CITY OF MENDOTA HEIGHTS

PLANNING COMMISSION REGULAR MEETING AGENDA

September 25, 2025 at 7:00 PM

- a. **CASE No. 2025-17 Conditional Use Permit** Application of M&M Home Contractors for a Conditional Use Permit (CUP) for residential building height for a new single-family home at 1867 Hunter Lane
- b. **Case No. 2025-18 Zoning Ordinance Amendment** Application of City of Mendota Heights for a Zoning Ordinance Amendment to complete minor clean-up updates to improve clarity and cohesiveness, add citations and remove conflicting language

1 RIGHT ELEVATION
SCALE: 1/4" = 1'-0"

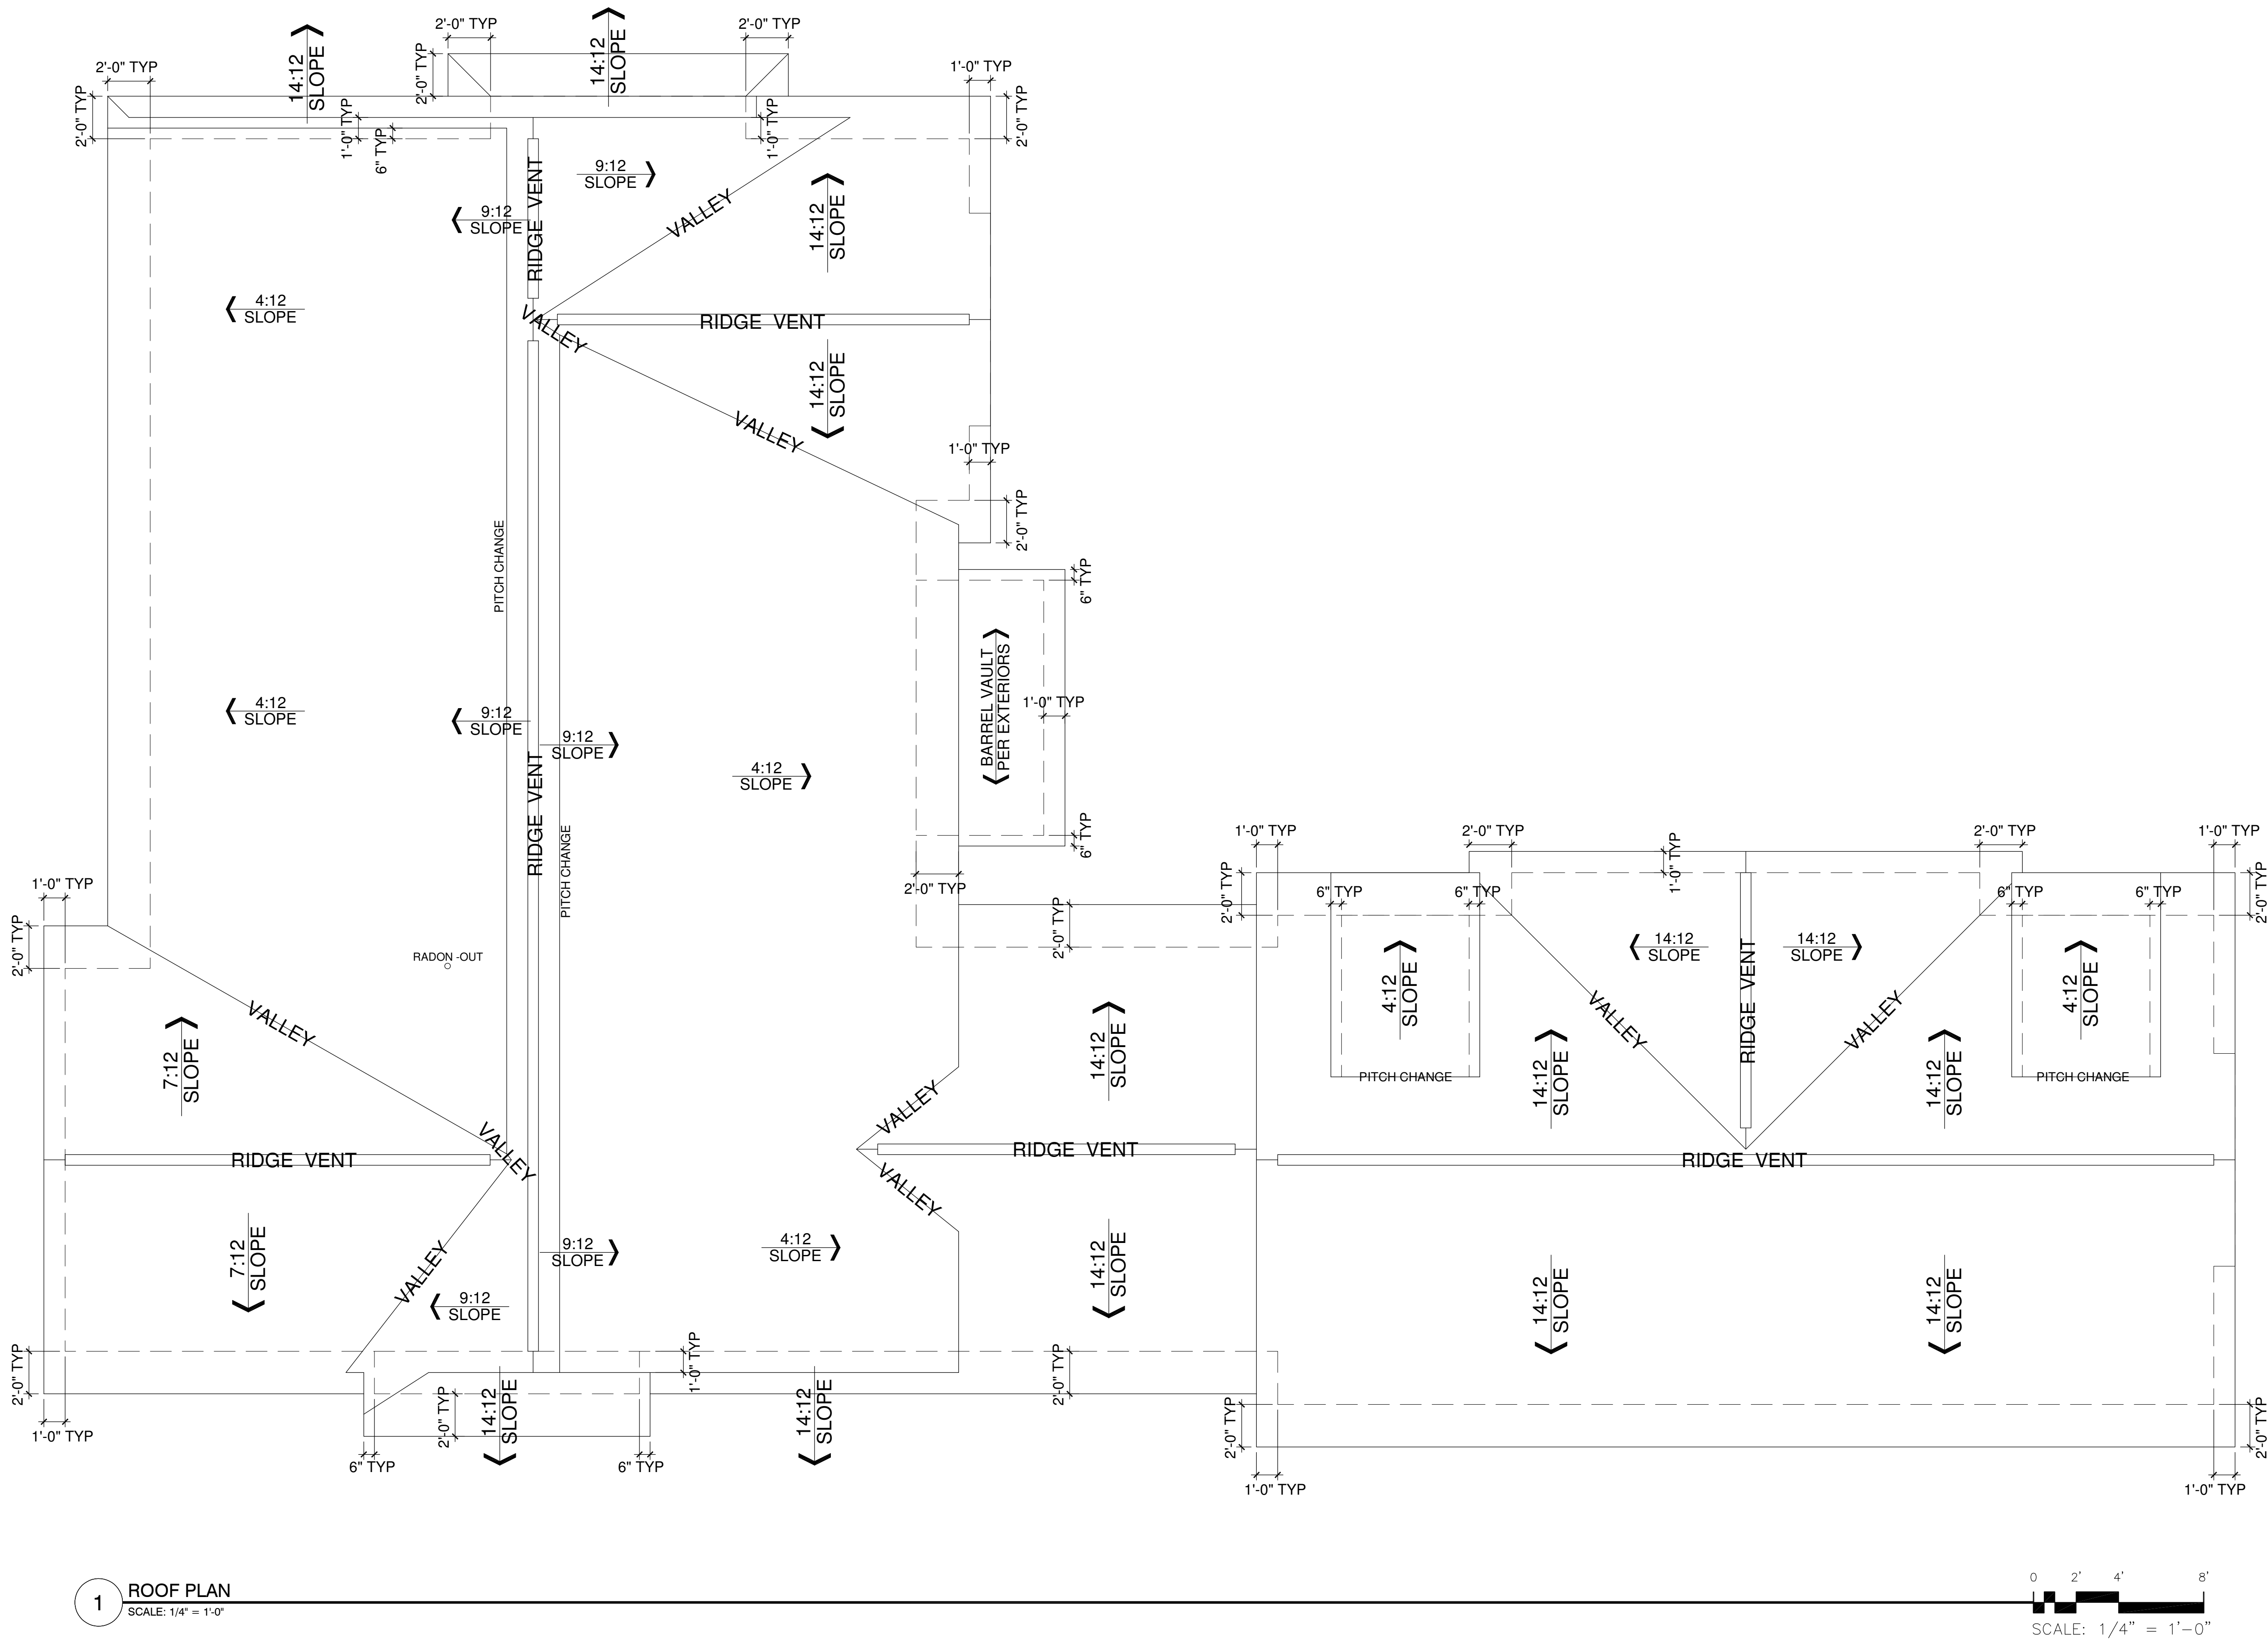
The applicant has revised the roof design to comply with the maximum 9:12 primary roof pitch now required by City Code. The primary roof structure, as illustrated on the provided plans A4: Right Elevation, contains roof pitches of 9:12 and 4:12. Ornamental roof elements exceeding a 9:12 pitch are located on the street-facing facade, with a 12:14 roof over the garage doors. This roof structure is secondary within the design, and the peak of this roof feature does not exceed the height of the primary roof structure at 9:12 pitch. There are also additional ornamental roof features over dormers with a 12:14 pitch. These features are subordinate to the primary roof and are consistent with previous staff interpretations allowing such architectural elements when they do not affect the height calculation of the primary structure. The City will be considering clarifying language to maximum roof pitch in the future to make it clear to applicants that the intent of the maximum roof pitch standard is to regulate overall residential structure height.

The project supports the Comprehensive Plan's goals for neighborhood reinvestment and compatibility in infill development. The applicant has revised the design to conform with roof pitch standards, and the proposed height is modest, reasonable, and consistent with the intent of the zoning ordinance.
